Commonwealth Edison

Subject: Dresden Station Units 2 and 3
Quad Cities Station Units 1 and 2
Review of Fire Protection Requirements
NRC Docket Nos. 50-237, 50-249,
50-254 and 50-265

ATTACHMENT 1

FIRE HAZARDS ANALYSIS

FIGURE 1

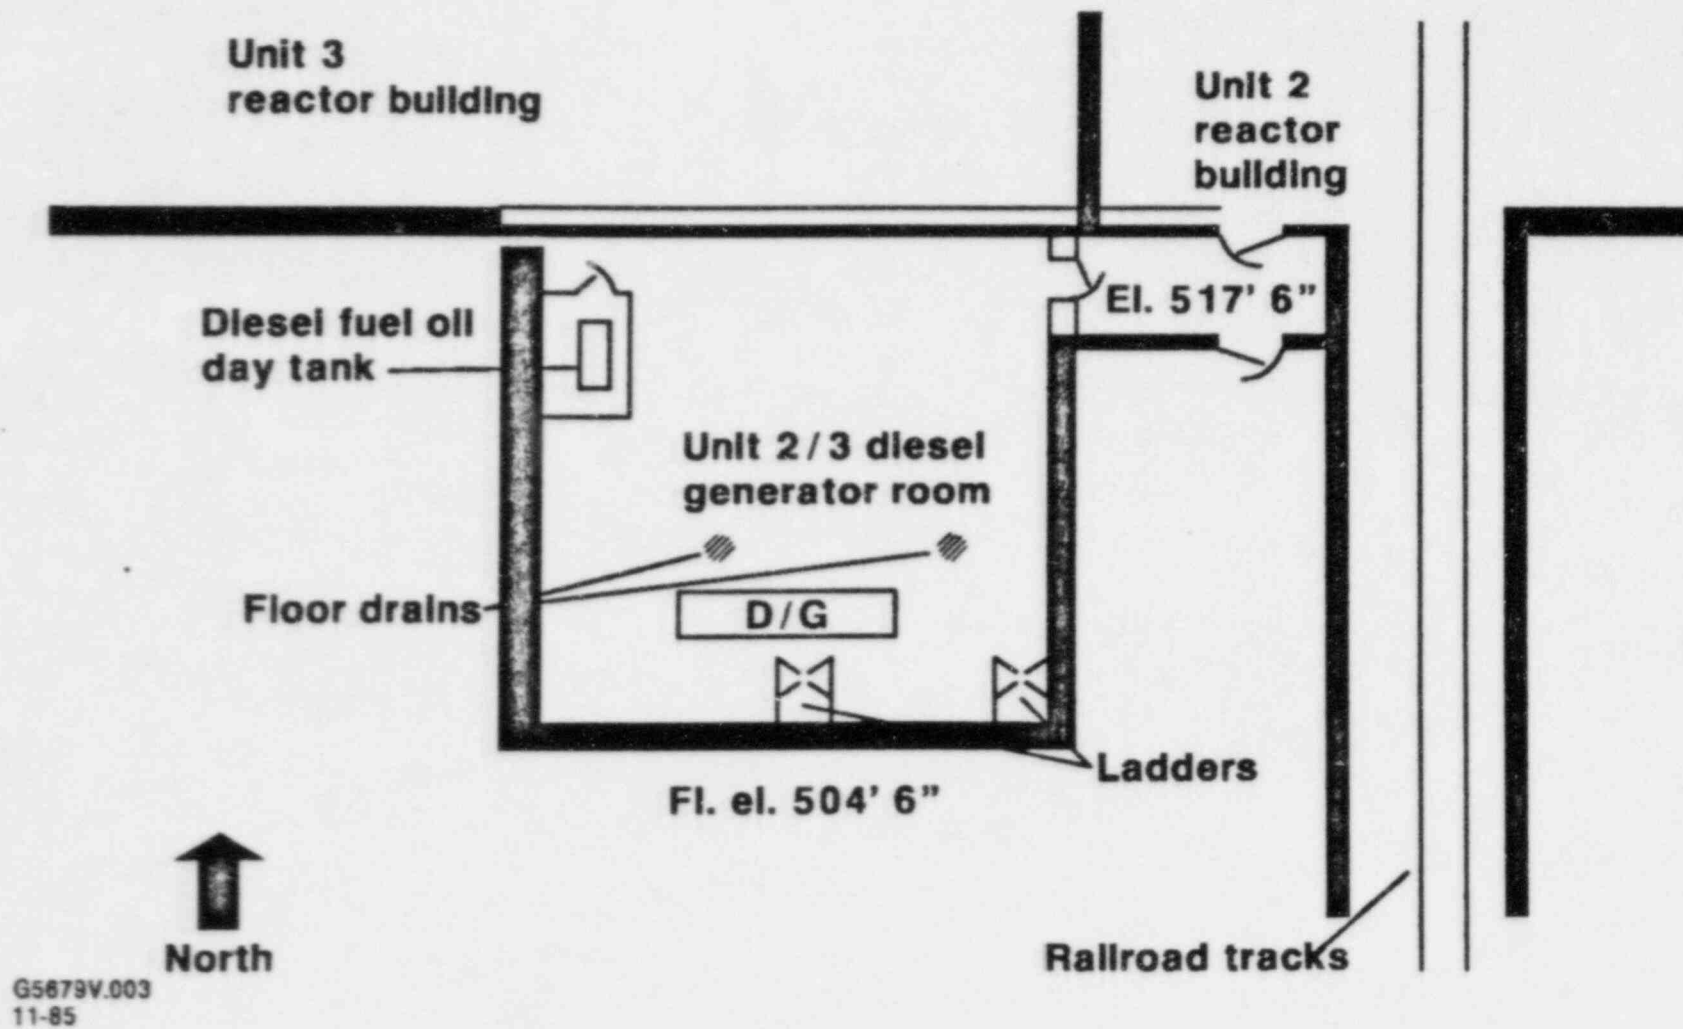
<u>ITEM</u>	<u>SER REFERENCE</u>	<u>DESCRIPTION</u>
3.1(a)	3.1.8	SER Section 3.1.8 states, "Fire doors will be provided...at the....diesel generator rooms." Fire doors were installed at the Turbine Building entrances to the DG2 and DG3 rooms. A fire door was not installed for the reactor building entrance to the 2/3 DG room through the secondary containment interlocked access corridor (heavy metal interlocked doors exist). Based on the brief description in the SER and previous correspondence, we believe a fire door was not intended here since this is an external door with no external combustible loads. The general policy used in the 1977 FHA was to install fire doors in external walls only when there was a clearly identified hazard outside. See Attachment 5 page 3 for the fire hazards analysis. See Figure 1.

3.1(b)	3.1.8	SER Section 3.1.8 states, "Fire doors will be provided...at the...diesel generator rooms." Since suppression exists in both the 2/3 DG and HPCI rooms, and two heavy metal doors are in place, a fire door was not intended and therefore not installed between the 2/3 DG room and the HPCI rooms. Refer to Section 2.3.9.7 of the 1977 FHA. See Attachment 5 page 3 for the fire hazards analysis. See Figure 1.

3.2	3.1.15	SER Section 3.1.15 states, "Curbs will be provided for the diesel generator room..." All doors in the DG rooms and Day Tank rooms have been provided with curbs except the entrance to the 2/3 DG room. A curb was not intended for this location since the entrance is 13 feet above floor level. See Attachment 5 page 3 for the fire hazards analysis. See Figure 1.

The diesel generator 2/3 room north wall separates this room from the Reactor Building (See Figure 1). This is a 3-hour rated fire barrier. The east, west and south walls and roof are exterior boundaries. These walls and roof are not fire rated. An unrated substantial metal door from the 2/3 diesel generator room eastwall opens to the secondary containment interlock corridor (See Figure 1). A door from the Unit 2 reactor building and from the exterior also opens into this corridor. The floor is a secondary containment boundary which separates the diesel generator 2/3 room from the Units 2 and 3 HPCI rooms. The floor is not fire rated. Unrated double doors provide access from the 2/3 diesel generator room to each HPCI room. The safety-related equipment in the diesel generator 2/3 room includes the 2/3 diesel generator, fuel oil transfer pump, and vent fans.

FIGURE 2

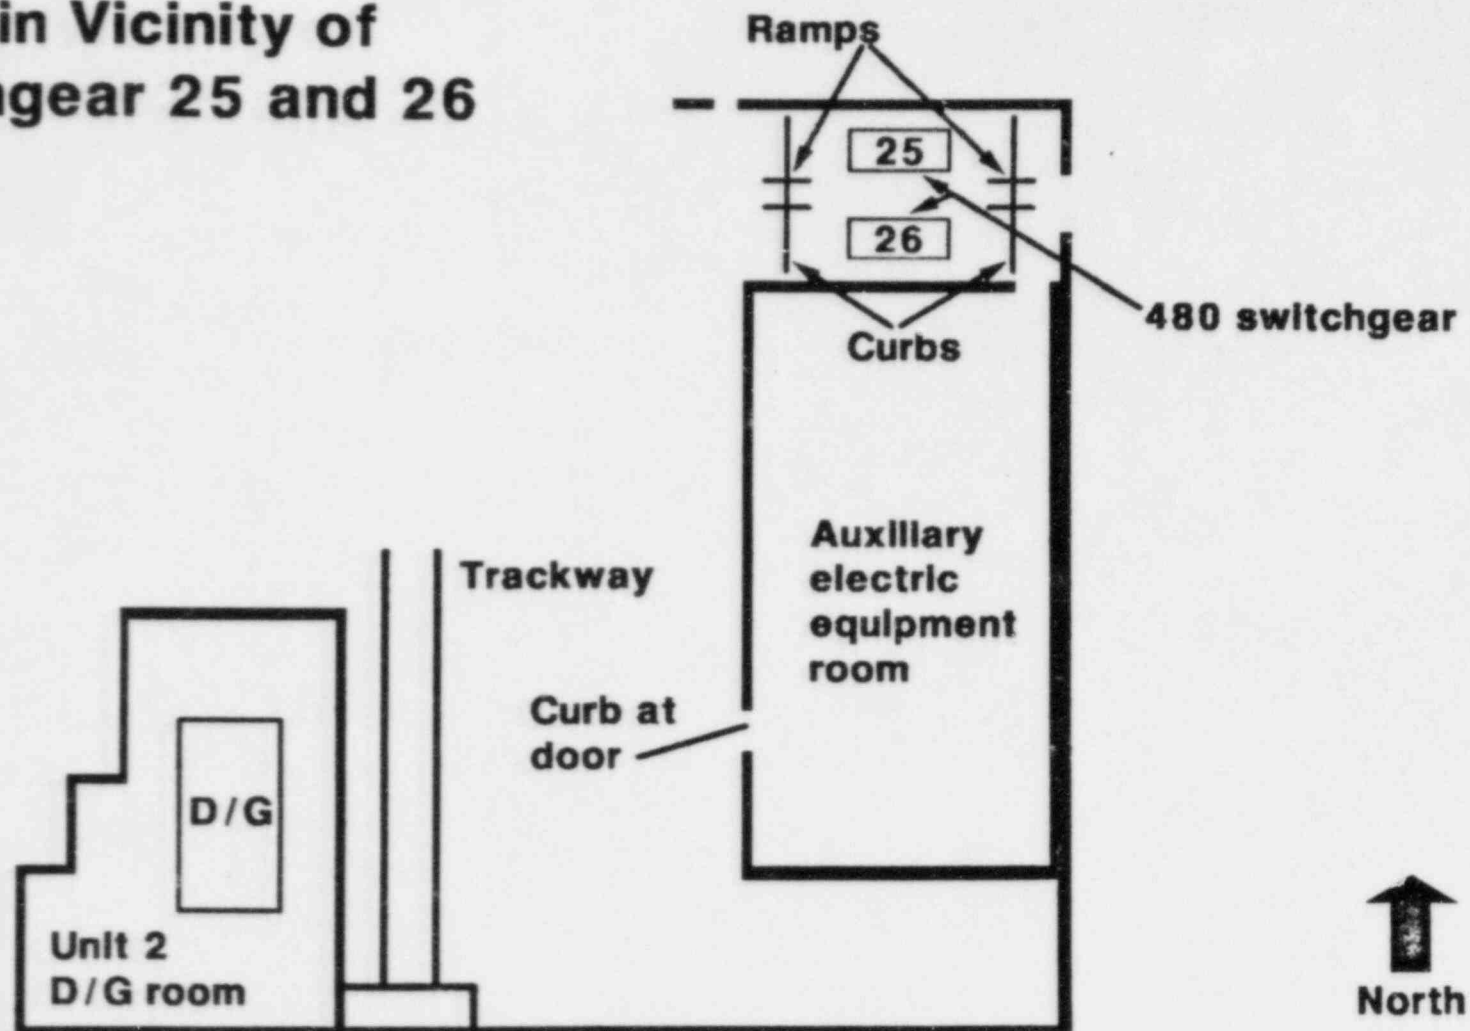
<u>ITEM</u>	<u>SER REFERENCE</u>	<u>DESCRIPTION</u>
3.4	3.1.15	SER Section 3.1.15 states, "Curbs will be provided at the entrance of the AEER room." The required curb was installed at the West door to the AEER to protect from potential transient combustibles in the Unit 2 trackway. A curb was not installed at the North door since curbs exist around adjacent 480V bus 25 and 26 transformers. These transformers are curbed and are the only fixed hazard in the vicinity. The north door does not access the Unit 2 trackway. See Figure 2.
